Planning Commission Staff Report

Project Type: Amended Architectural Elevations

Description: **Spirit Trade Center, Lot 12A (Club Dog)**: Amended Architectural Elevations and Amended Architect's Statement of Design for a 2.01 acre "LI" Light Industrial District – zoned property located a half mile southwest of the intersection of Chesterfield Airport Road and Trade Center Boulevard.

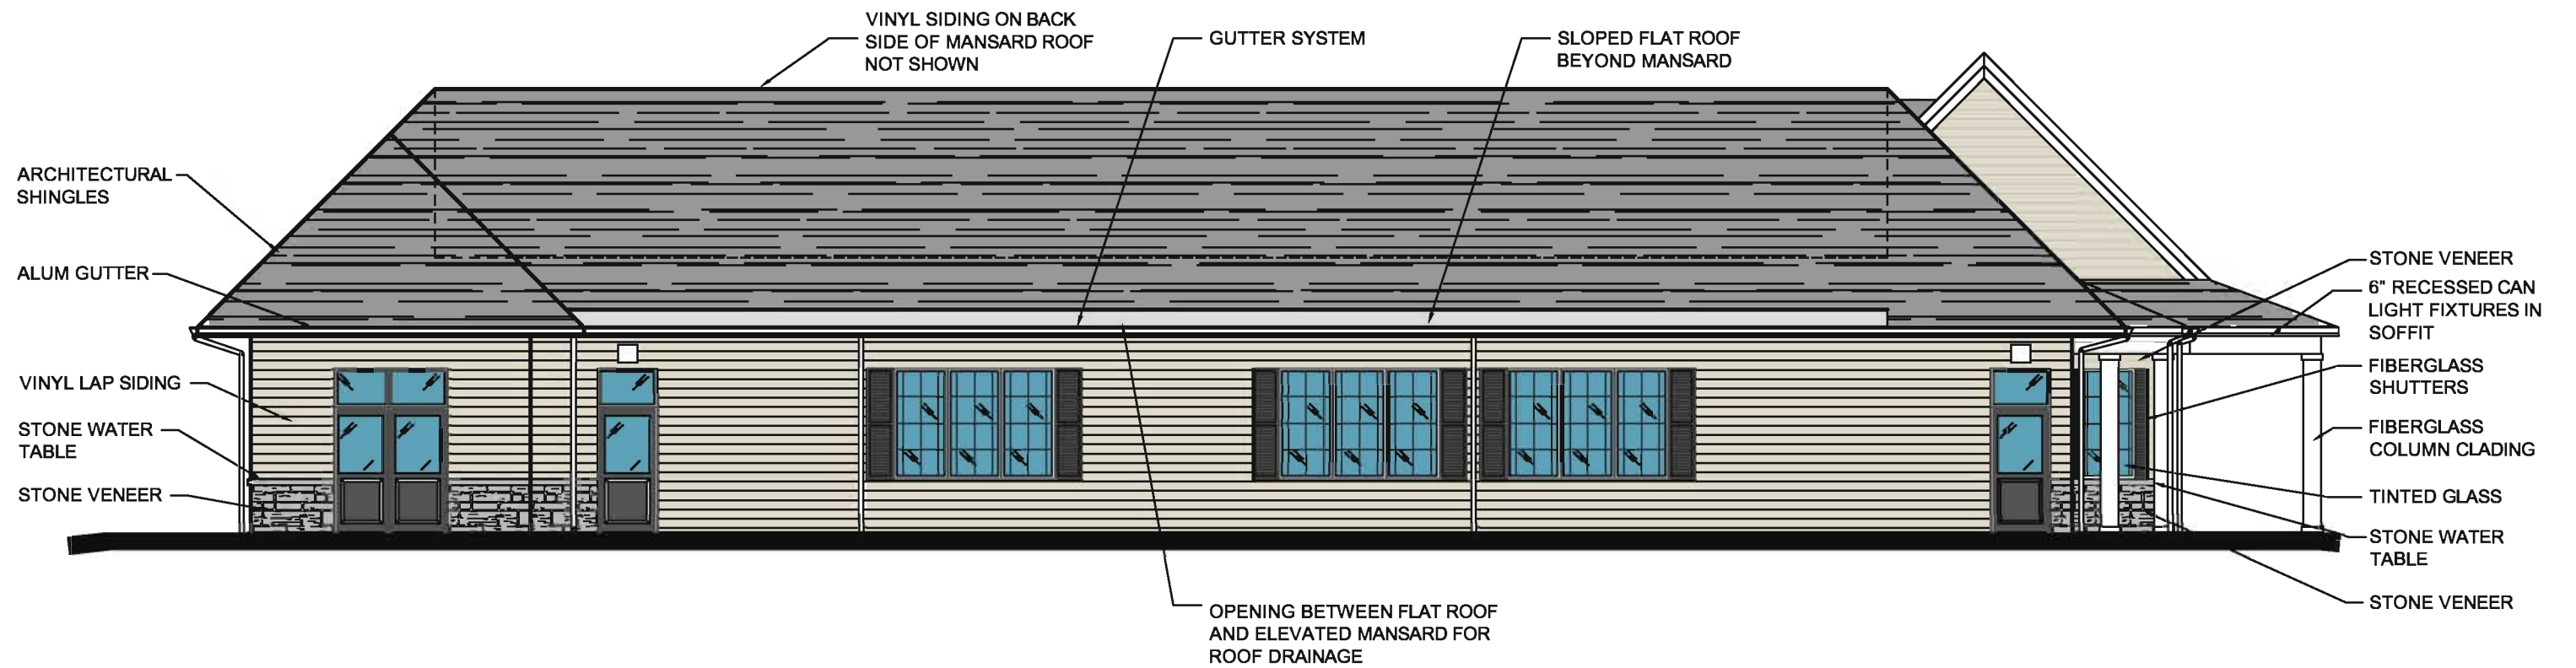
The Amended Architectural Elevations were presented to the Planning Commission on May 14, 2012. At that meeting the Commission raised concerns regarding the allocation of stone veneer around the base of the building. The concern expressed by members of the Commission was that the stone appeared "unbalanced" and did not seem to be placed in an organized manner at the ends of each elevation. Comments were also made regarding the stone veneer and whether it should line up with the edges of the windows. The Commission directed those concerns to Mr. McLain who was the General

1. Eliminate the stone from the upper portion of the walls along the front elevation.
 - The applicant has elected to remove the stone from the upper portion of the front (south) elevation reducing it down to the wainscot height.
2. Stone should be added at wainscot height on all four sides of the building but at least on both corners of the north, south and west elevations.
 - The applicant has added stone to all four sides of the building using the material to wrap each of the corners at wainscot height.
3. Revise the roof on the west elevation to mimic the appearance of the original roof design and incorporate visual screening of the planned rooftop mechanical equipment.

- The applicant has added the mansard roof back on the western elevation to give the appearance of the original roof design and to screen rooftop mechanical equipment. The west mansard roof will have a one (1) inch gap for sheet drain purposes.

On May 21, 2012, Planning and Development Services Director Aimee Nassif contacted the Architectural Review Board Chair and forwarded the new elevations to him for comment. The Architectural Review Board Chair advised that the elevations, as now presented, fully meet what the Board was looking for. In addition, the Chair advised the Director that they had purposely left it up to the architect to determine the most logical point of termination for the stone veneer.
